UNITED STATES PATENT AND TRADEMARK OFFICE

Office Action Summary

10/554,316

CARMAN ET AL.

FIG. 6

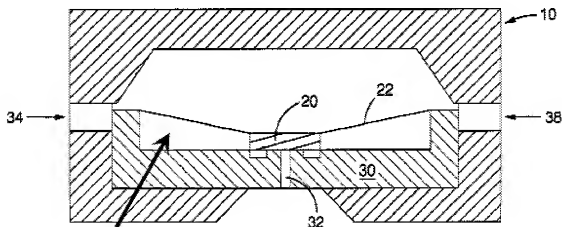
9. In Re claims 1 and 14, with reference to Figure 6 depicted above, Knebel et al discloses an actuation mechanism (title) comprising:

- an actuator body (10) comprising an actuation chamber (interior space) having a membrane seat surface (30)
- a membrane (22) comprising a shape memory alloy (SMA) that has a martensite-austenite transition temperature (Column 1, Lines 20-32: "...when the alloy is heated above a temperature threshold, the transition temperature, its crystal structure changes to austenite and the alloy returns to its original configuration..")

- said membrane being located over said membrane seat surface as depicted to define a pump chamber between said membrane seat surface and said membrane.
Note that the inlet (34) has a higher diameter than the orifice (32) therefore the velocity of fluid exiting is higher than at entry since the volumetric rate is maintained for an incompressible fluid (fuel), therefore the fluid is "pumped" to a higher velocity.

- at least one inlet (34, 38) through which fluid is introduced into the pump chamber
- at least one outlet (32) through which fluid is removed from said pump chamber, said outlet being located at a spaced location from the inlet (outlet is in the center and inlet is at the periphery)

FIG. 3

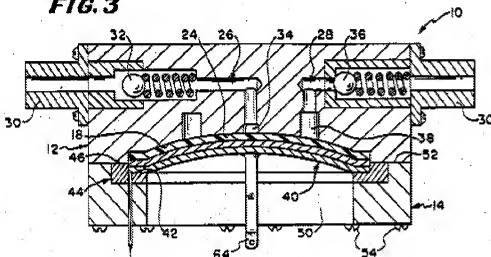
19. In Re claims 1 and 14, with reference to Figure 3 depicted above, Brown discloses an actuator body (10) with an actuator chamber (50) and pump chamber between deformable diaphragm/membrane (40) and seat (18), the diaphragm/membrane (40) comprising a bi-metallic element (58) and gasket (60), inlet

(34), bias pressure applicator (32), outlet (38) and heating elements (Column 5, Lines 35-38).

20. However, Brown does not disclose that the membrane comprises a shape memory alloy, introducing fluid at or below the transition temperature and a heating system that heats the membrane to above the transition temperature.

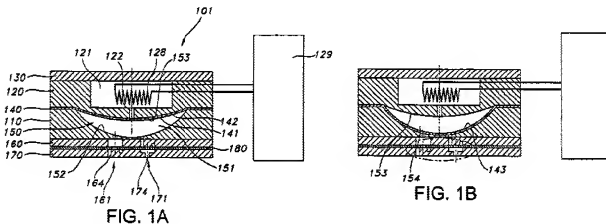
34. Nevertheless with reference to Figures 1A and 1B depicted above, Hansen discloses a dome shaped protrusion (153) extending into the pump chamber (formed between surface (143) of the membrane and the dome, the pump chamber is a part of the actuation chamber). The dome shape is a seat for the membrane.
